**RFP# PW-25-01
CORDOVA 17 MILE LANDFILL SURVEY
ADDENDUM # 1**

This addendum forms a part of the RFP# PW-25-01
CORDOVA 17 MILE LANDFILL SURVEY Request for Proposals

Site Plan

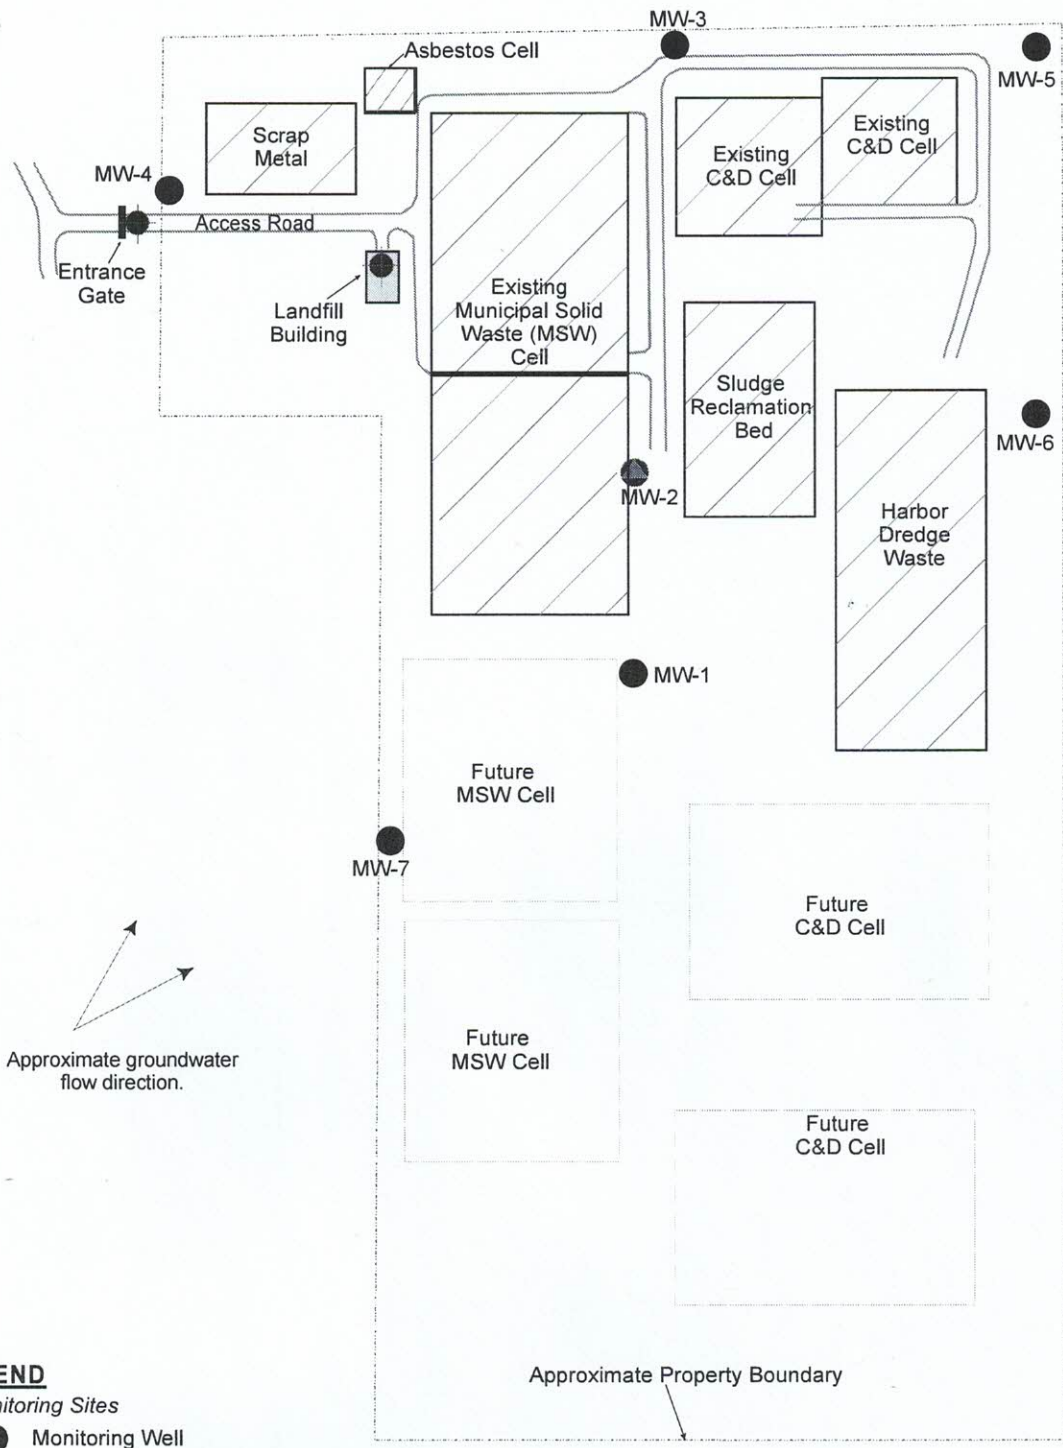
AD-5 How many monitoring wells (approximately) are on the site?

Response: There are 7 monitoring wells. Site plan attached to this addendum shows their approximate locations.
